ADDRESS:
NEW MIXED USE DEVELOPMENT
 575 4th AVENUE
 BROOKLYN, 11215

PROJECT INFORMATION:
**10TH FLOOR
 COMBINED SERVICES LAYOUT**

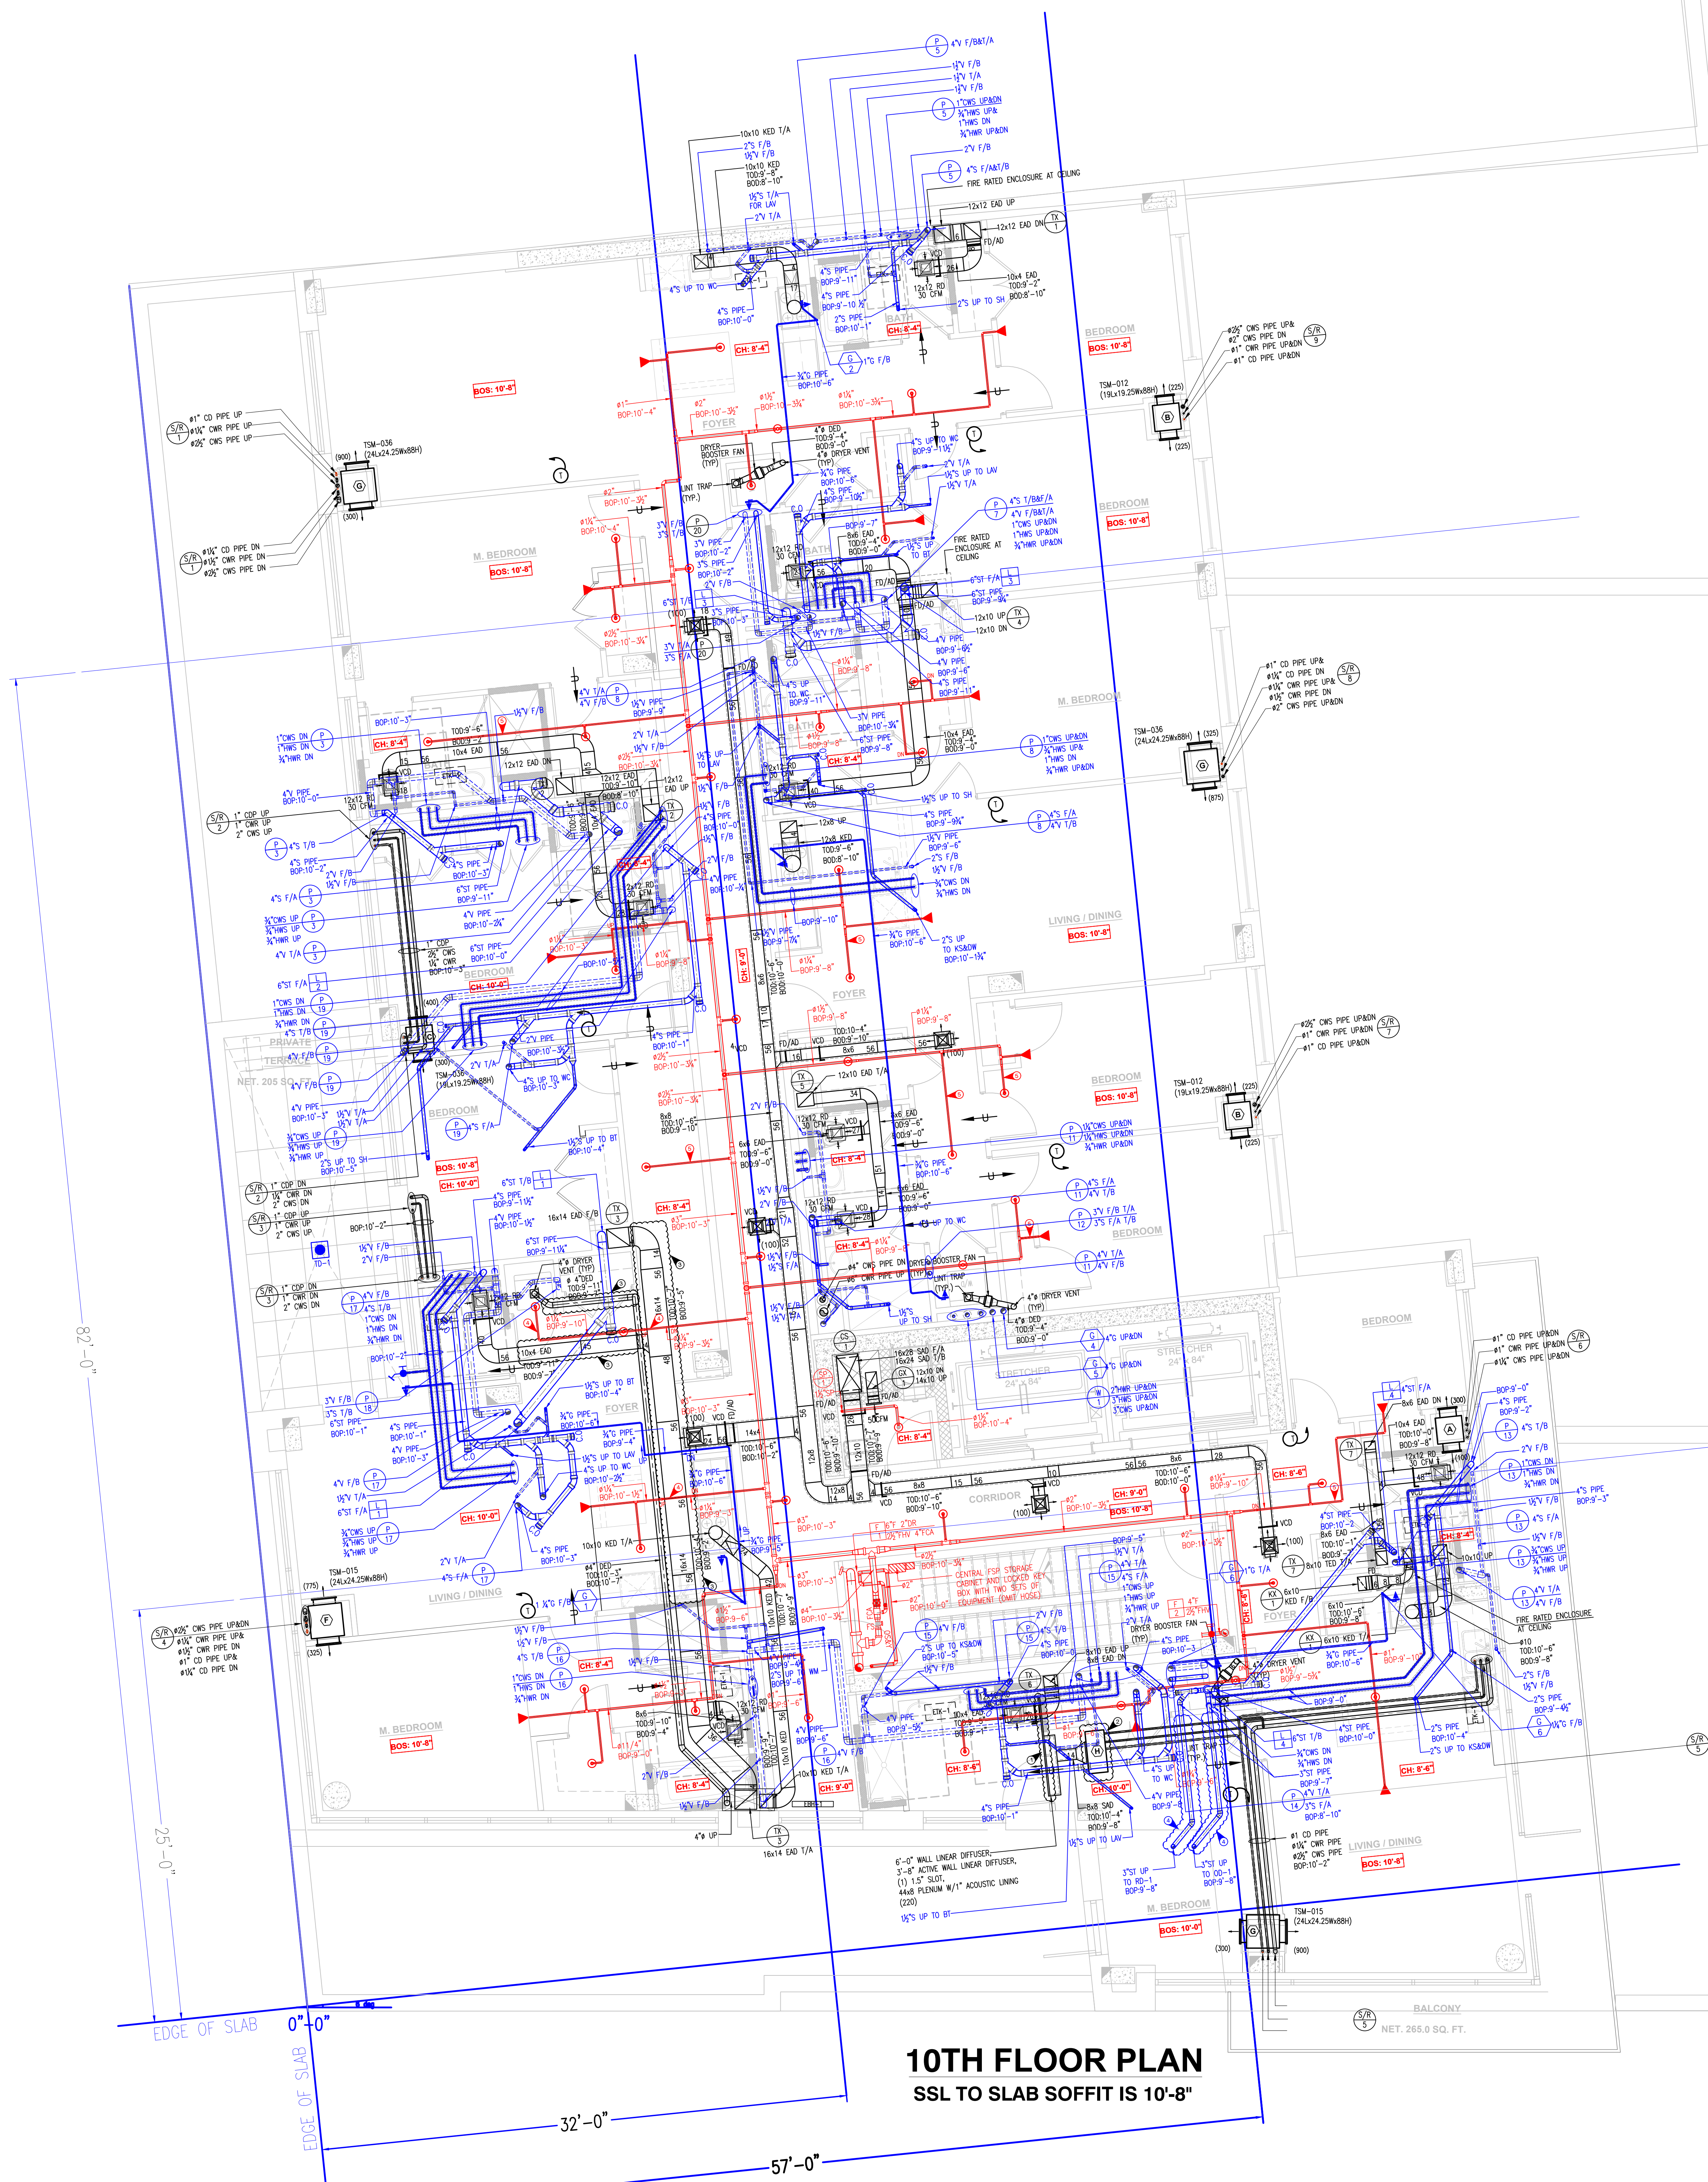
- 1 WALL LINEAR DIFFUSER IS COMING ABOVE THE TOILET REFLECTED CEILING LEVEL.
- 2 HVAC UNIT SUBMITTAL NOT AVAILABLE.
- 3 DUCT RUNNING BELOW THE REFLECTED CEILING LEVEL.
- 4 PIPE RUNNING BELOW THE REFLECTED CEILING LEVEL.
- 5 PIPE SIZE NOT AVAILABLE IN GIVEN SPRINKLER DESIGN DWG.
